# New Outside Metal Closure

As an ongoing effort to improve the erectability of our products, add value, and expand services; American Buildings Company is announcing the following changes to the Standing Seam II and Standing Seam 360 Roof Panel Systems:

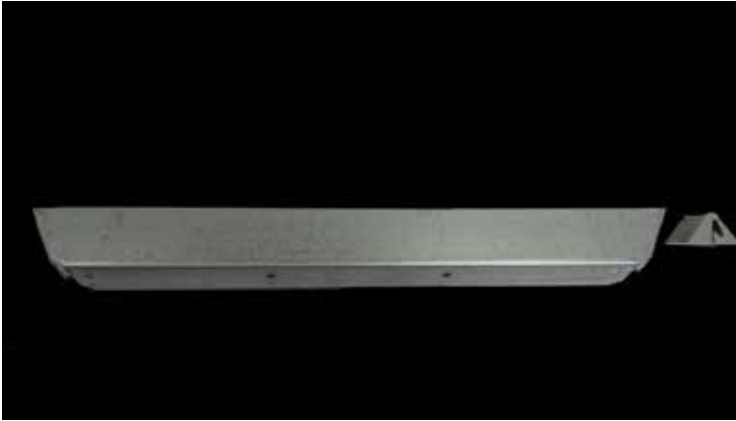
Current Outside Metal Closure with Required Foam Closure

New Outside Metal Closure

Effective June 29, 2015, projects with SSII or SS360 outside closure requirements will be processed using the new and improved Outside Metal Closure. This closure eliminates the need for the foam closure. In addition, this closure will be used in conjunction with Lap Stiffeners in lieu of Ridge Support Flashing at Ridge, High Side Eave and High Side Roof to Wall Conditions. These changes improve weather tightness and provide a more erector friendly installation.
